Supporting Statement

Littlehampton Road, Ferring

ASDA Ferring

10.120_Asda Ferring_Supporting Statement Document

Main Customer Elevation Amendments

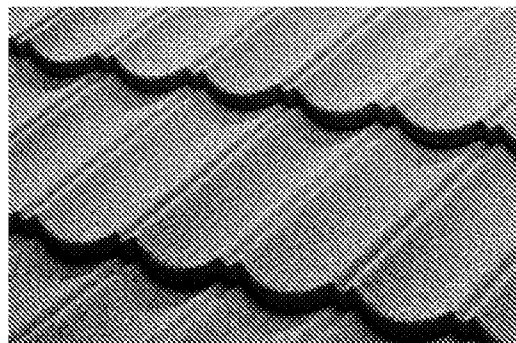
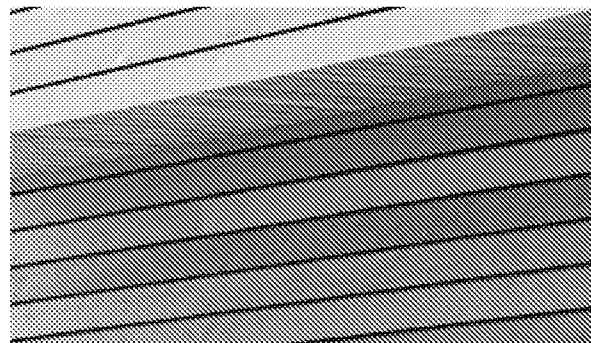
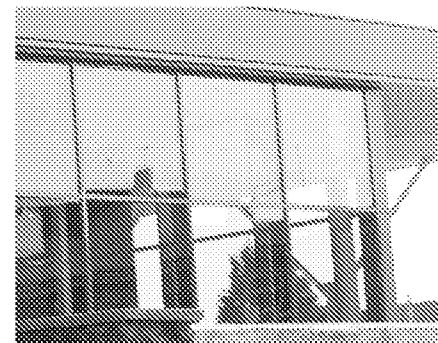
To improve clarity and comfort for the customer, a revised larger scale entrance lobby has been proposed. This element functions better as the main focal point, and improves the entrance at ground level by providing a curtain walled draught lobby.

Four dormers were removed and the remaining four relocated along the mansard to ensure correct proportionality with the increased lobby. Areas of glazing have also been amalgamated into two larger areas of glazing to increase light admittance and customer views into and out of the store.

The customer facing elevation has been enhanced with horizontally laid timber boarding in preference to the consented red brick. This attunes with Asda's corporate aesthetic for new stores and looks to reinforce further the rural aesthetic of the building. This use of FSC sustainably sourced timber aligns with the retailer's prevailing sustainability agenda.

The low level brick pilinth that wrapped the East, South and West elevations has been removed after discussions with the Local Authority regarding the lack of customer interaction in these areas and therefore the lack of requirement for enhancement along these elevations. The grey composite panel cladding as discharged as a material condition in the application FG/08/11/DOC remains.
